155041.006.002

Subject: Response to Comments Letter, February 1, 2021
Notice of Intent
Former Aerovox Facility, RTN 4-0000601

Site Plans to Accompany Notice of Intent

**WETLAND
RESOURCE AREAS
PLAN FOR
AEROVOX**

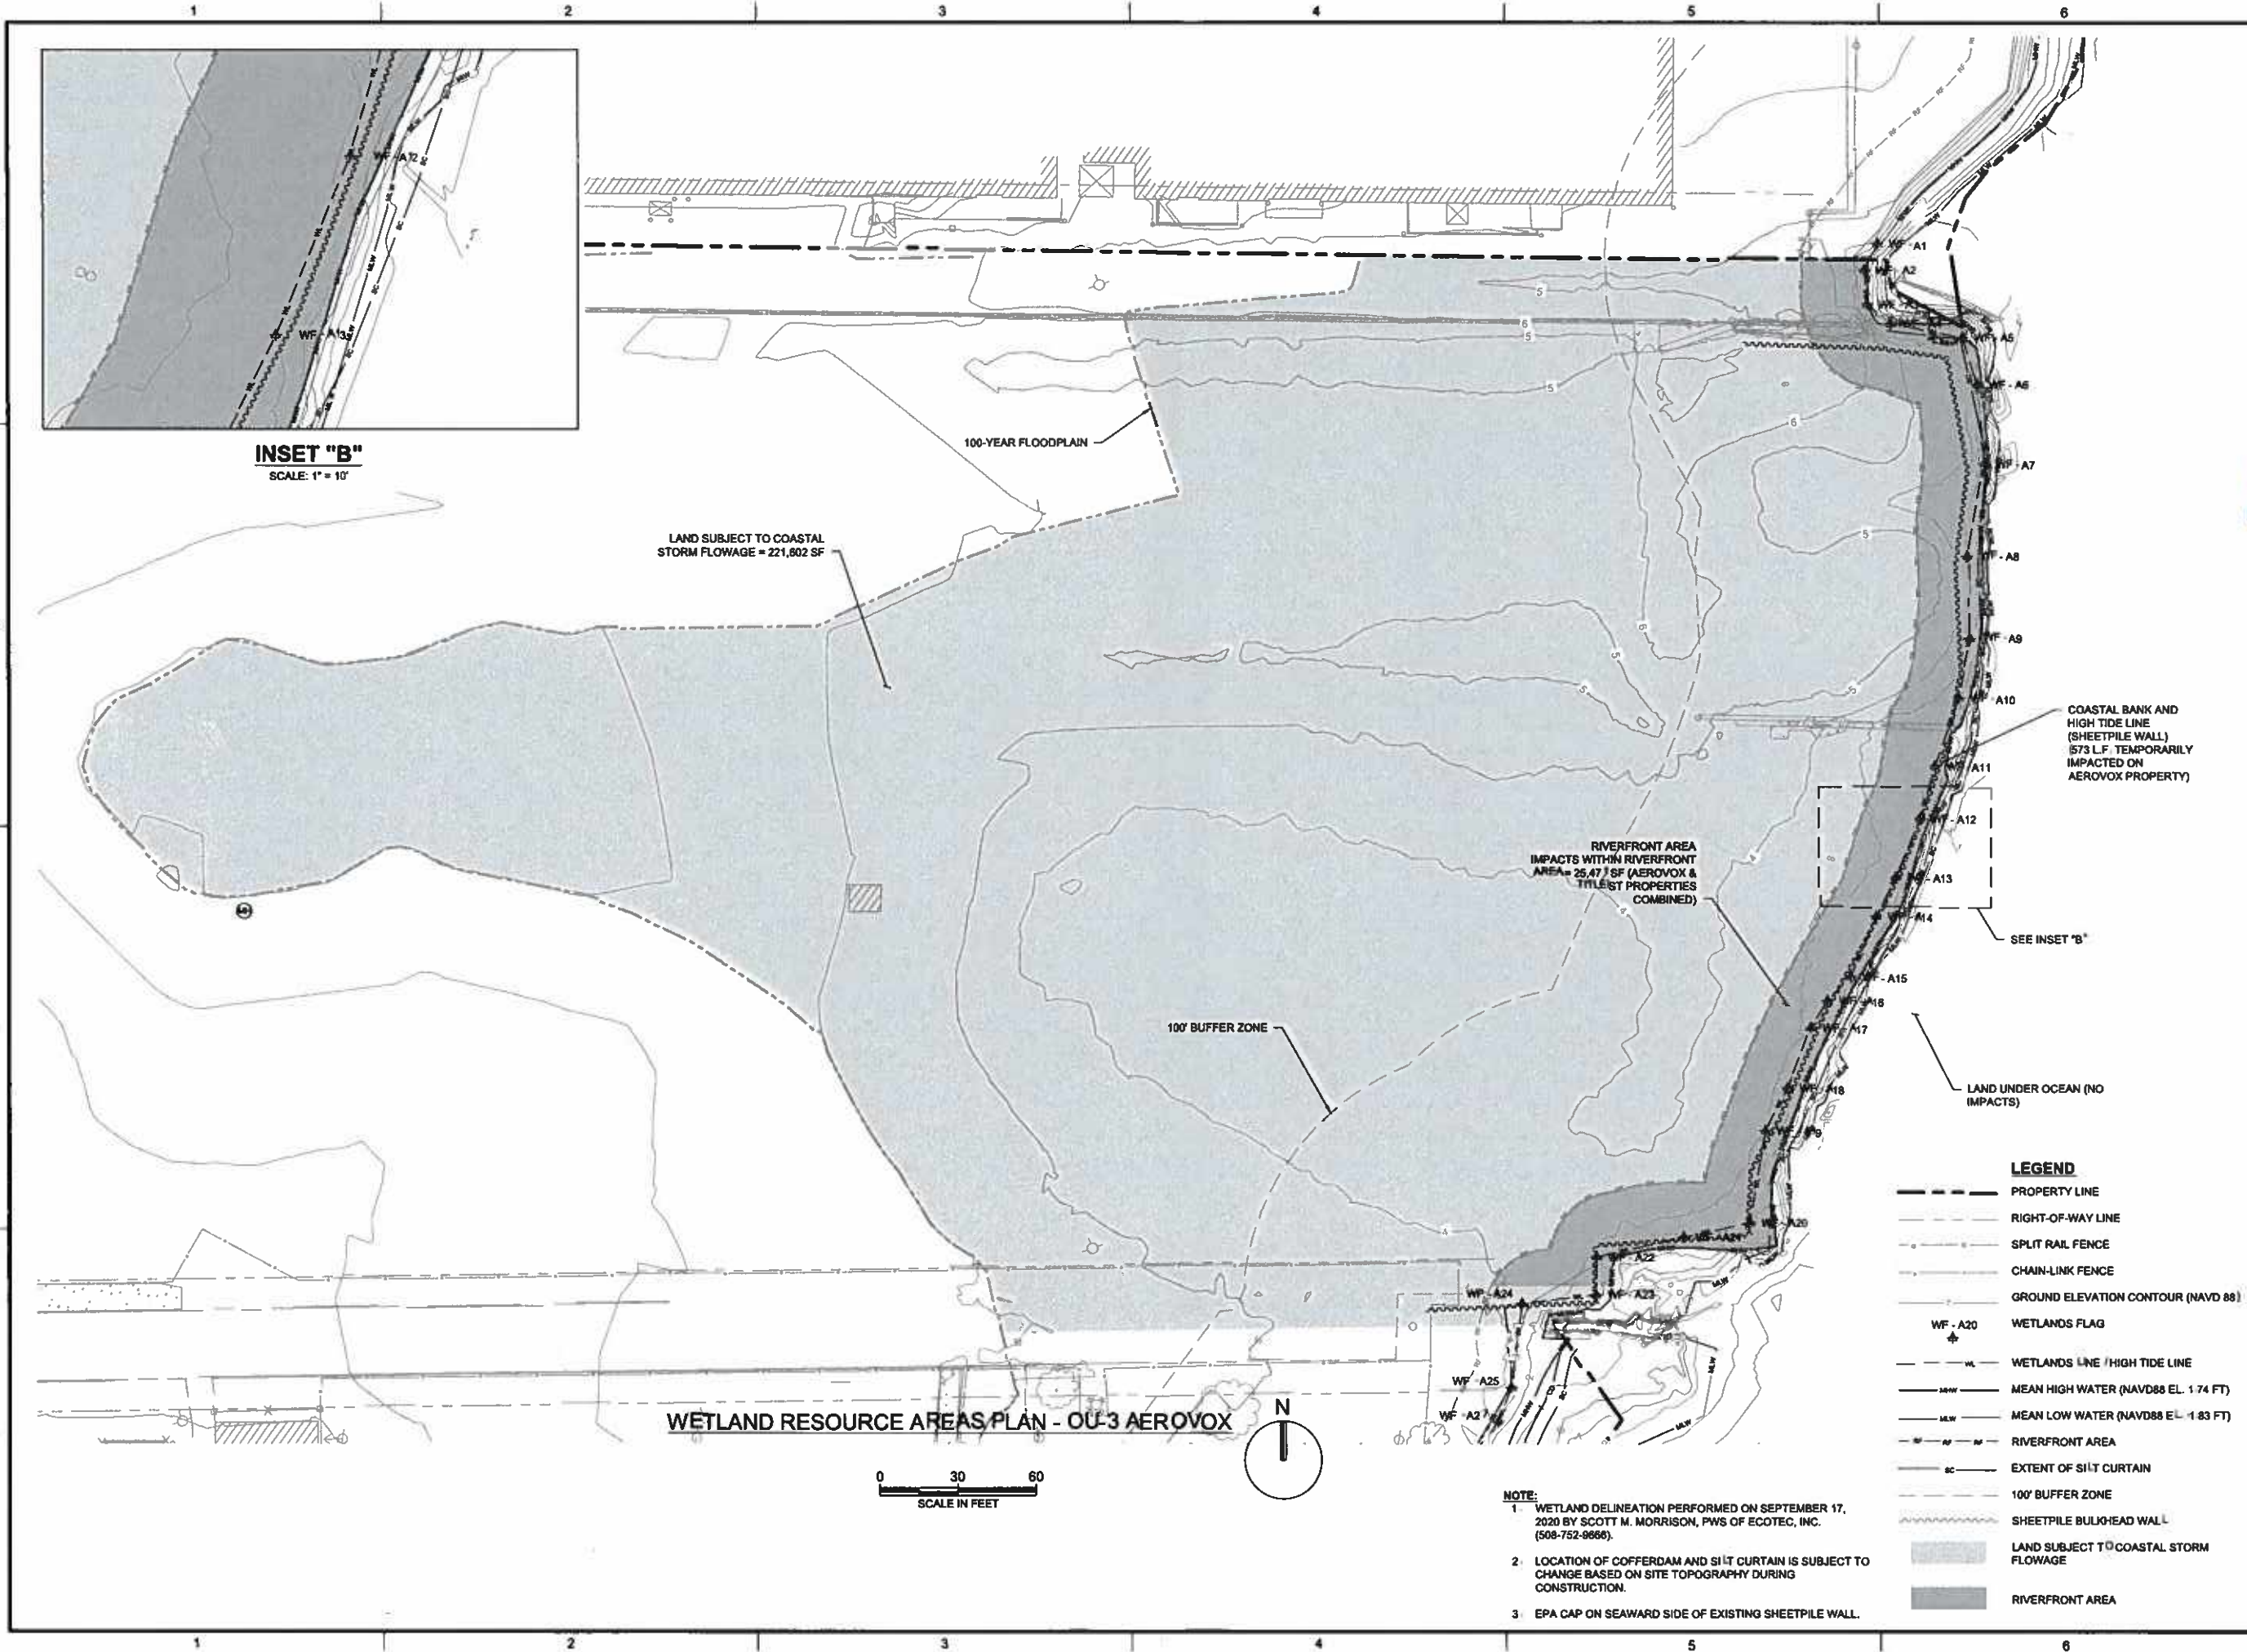
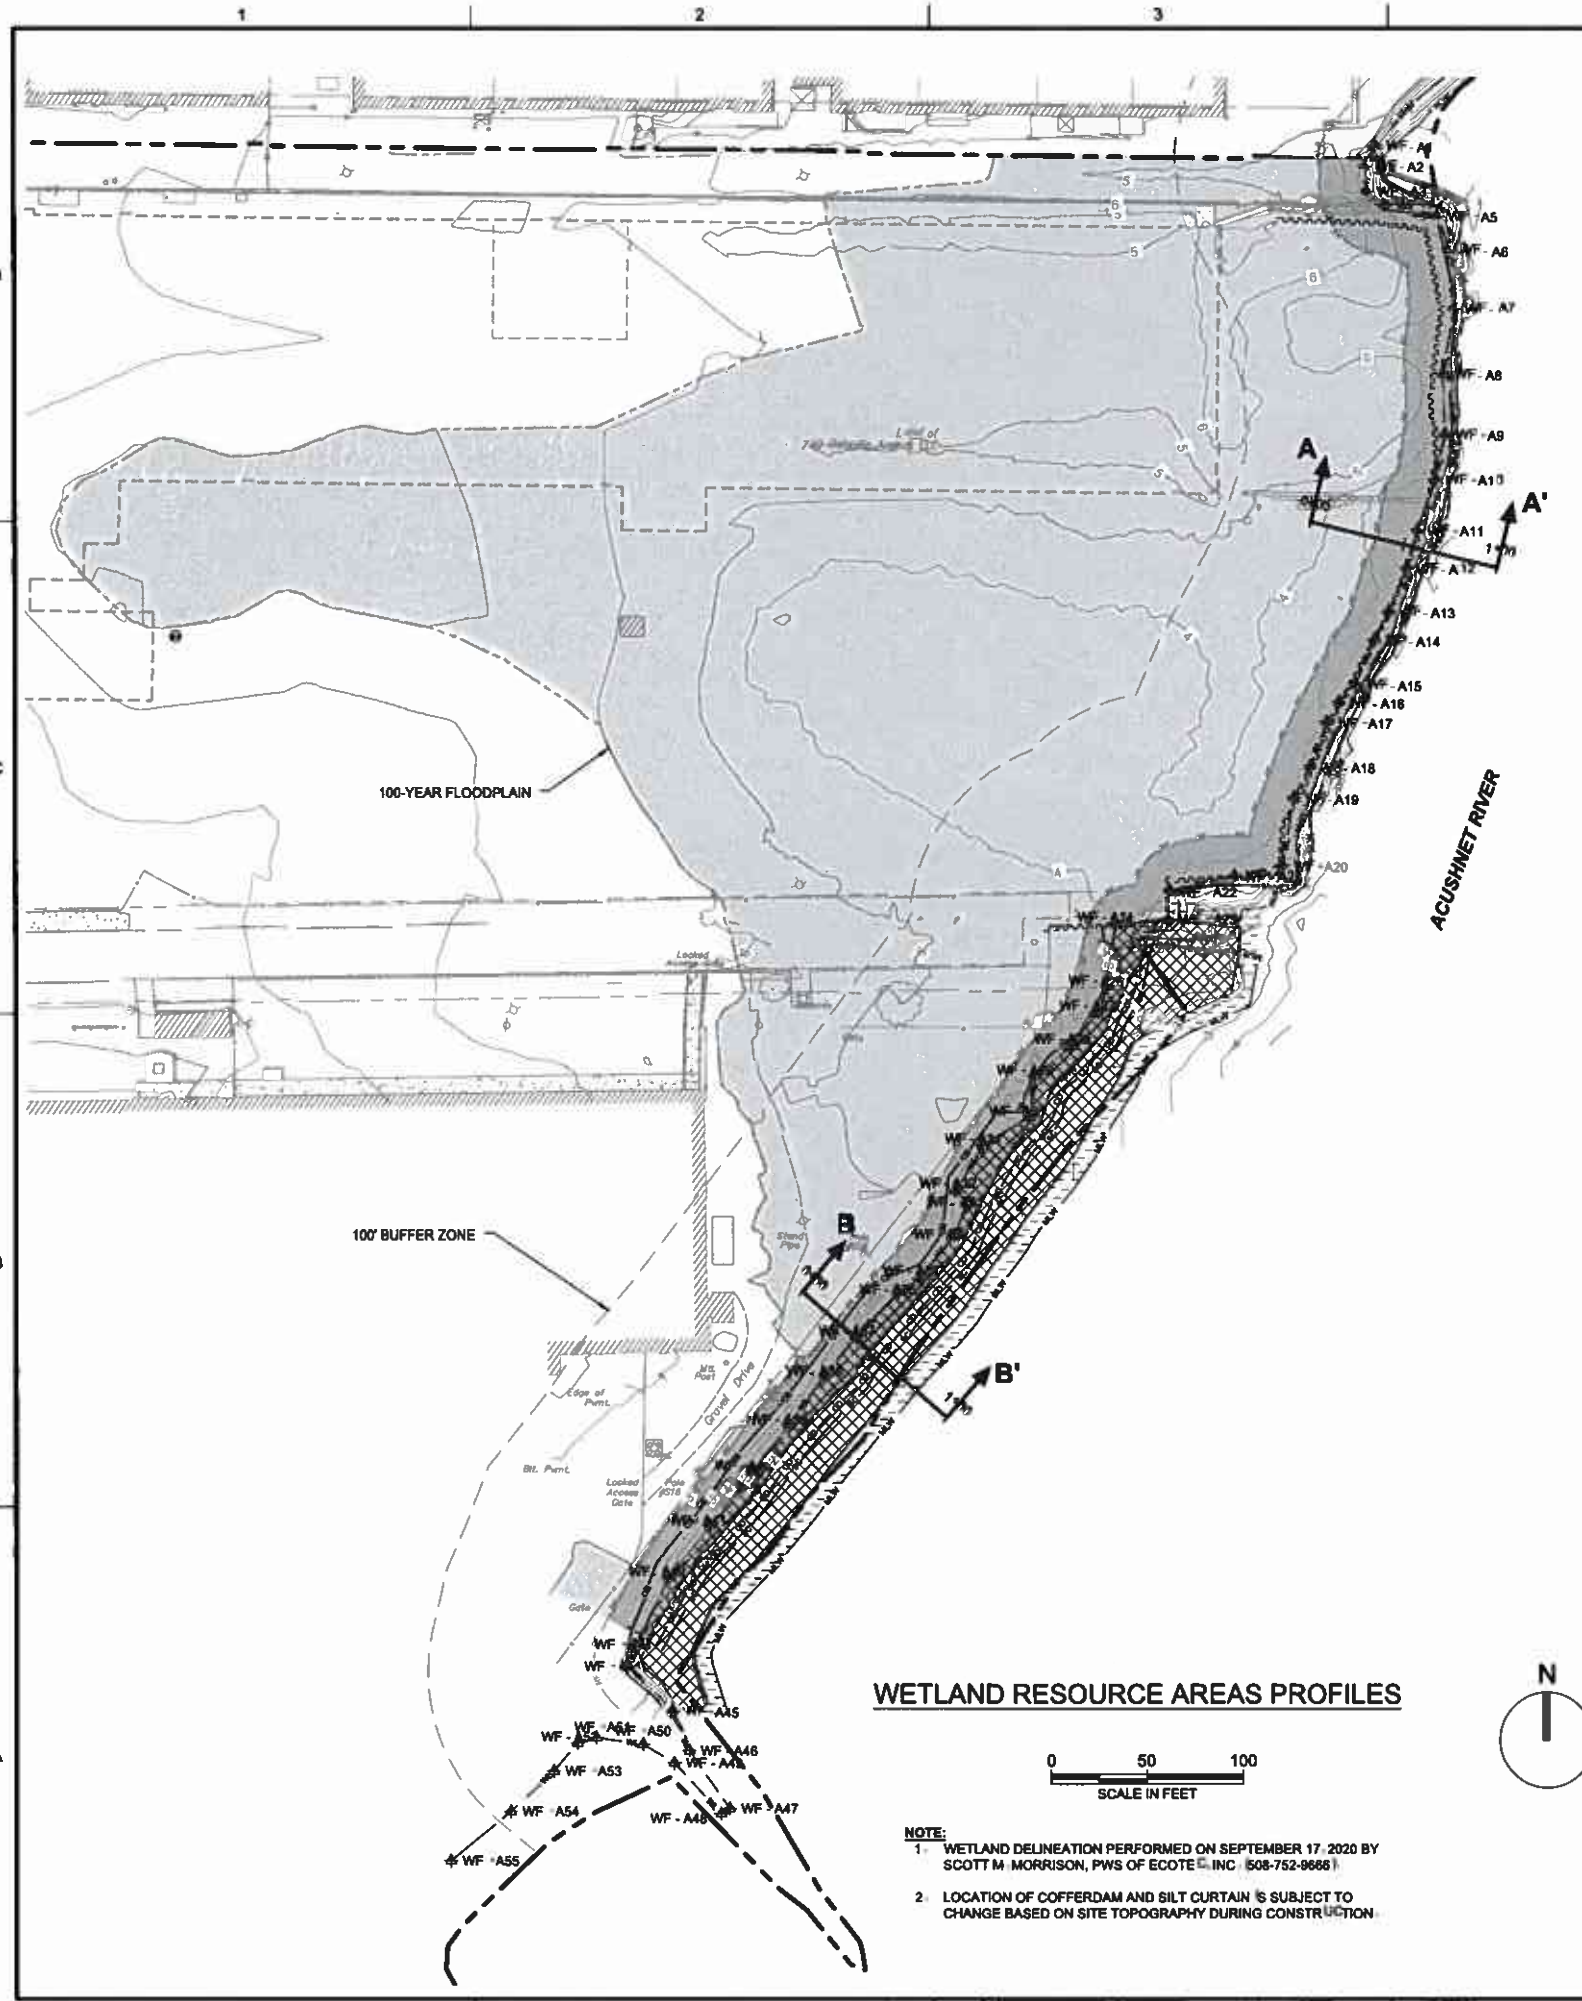
- 2. Comment:** *Although the subtidal areas offshore from the Aerovox property were not directly assessed during the site visit, given the shellfish resources present on the adjacent [Titleist] property, unless there is direct evidence to the contrary (i.e., a shellfish survey that found no evidence of shellfish), as a conservative measure we recommend considering all areas seaward of MLW as land containing shellfish as well. Although these areas are outside the area of direct influence from the project, they are within 100 feet of the project boundary and should also be included on the existing conditions plan.*

32. Comment: *The same table on page 2 of the report describes three discrete sets of wetland flags: A1 to A23 were blue ground flags delineating the HTL, A23 to A67 were blue flags delineating the upper boundary of the BVW, and B1 to B13 were red flags delineating the BVW boundary southeast of the site. These flag locations are not labeled on the wetlands figure.*

33. Question: *What location on the site plans does this [BVW] form correspond to? Without flag numbers on the plans, it's not possible to tell where this information was collected.*

Response: As discussed during the call between BC and Woods Hole Group, the EPA cap is located on the seaward side of the existing sheet pile wall, and BC does not have information regarding specific wetland resources prior to the installation of the cap. A note has been added to Drawing C-300 to indicate the location of the cap.

occurred. EcoTec flagged high tide on the Aerovox property (Flags A1 – A23 on Drawing C-300), which falls above the MHW line.

The locus for EcoTec's inspection extended further south than the NOI site plans to make sure that the extent of coverage was obtained. The Bordering Vegetated Wetland (BVW) delineation is located further south than the current project locus. As such, the delineated BVW and associated (upland & wetland) test plot flags are located southerly and beyond the work area of the NOI and therefore will not be depicted on the site plans. Flag numbers associated with the work area have been added to Drawings C-200 and C-300.

Response: Flag numbers have been added to Drawings C-200 and C-300. As discussed in the response to 32, BVW is located south of the work area.
